# Observations regarding Energy Efficient 1000BASE-KX

**IEEE P802.3az Task Force Meeting**  
**Dallas, TX**  
**November 2008**

## Summary of issues with Draft 1.0

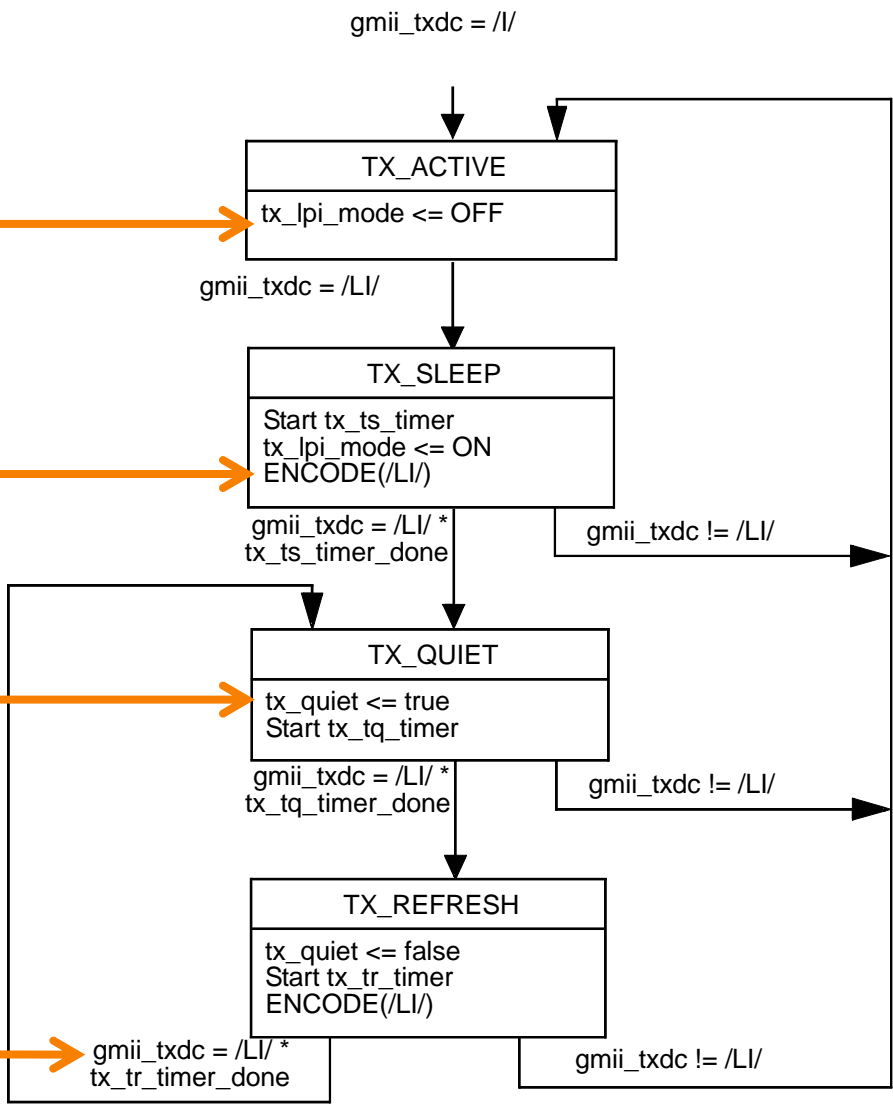
Who uses tx\_lpi\_mode?

ENCODE is really a PCS-level function

Who uses tx\_quiet?

gmii\_txdc presumes that the PMD has access to the GMII

Who uses rx\_lpi\_mode?

pcs\_rxcd presumes the PMD has access to the GMII?

How does the PMD know the result of this PCS-level function?

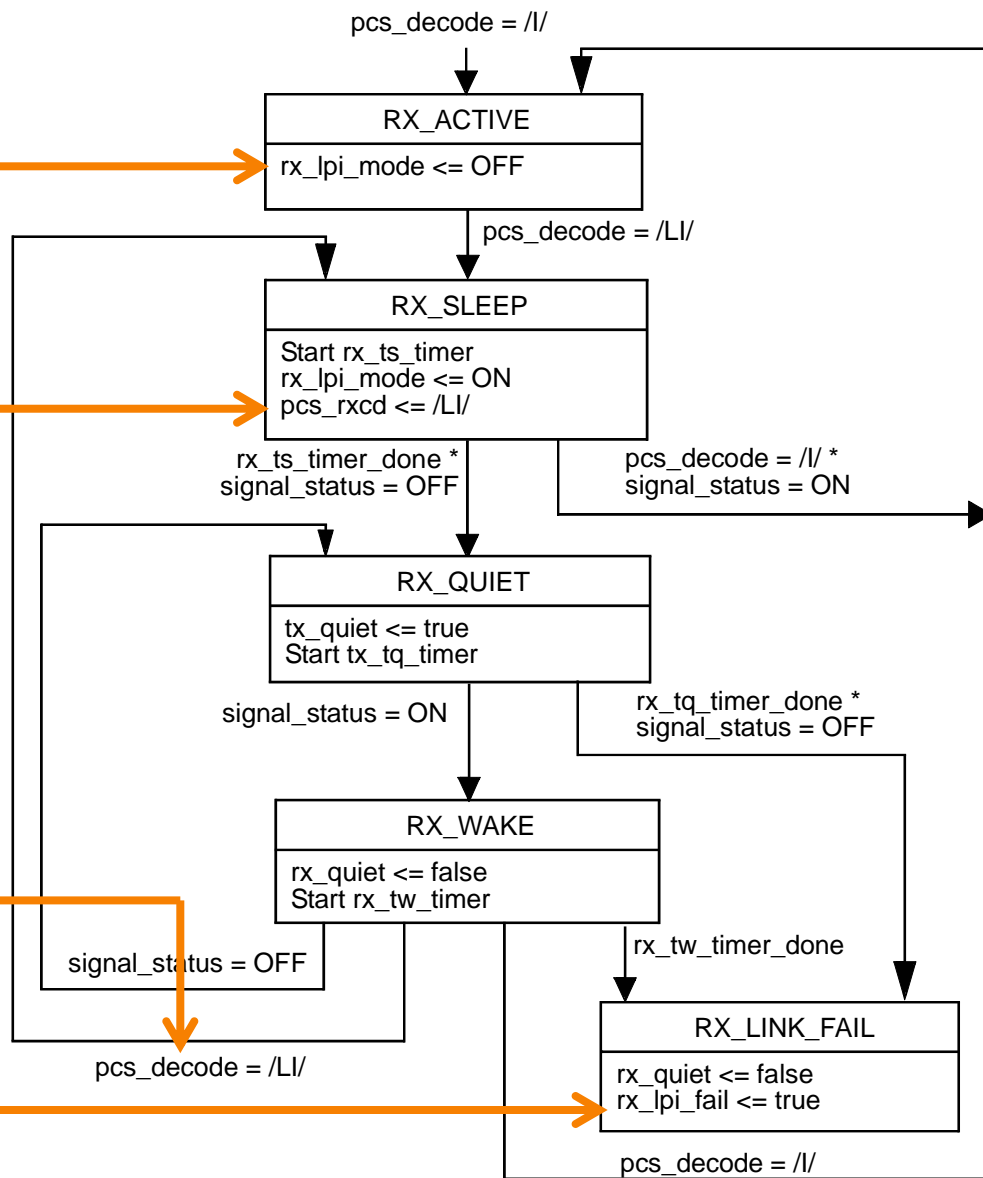
Who uses rx\_quiet or rx\_lpi\_fail?
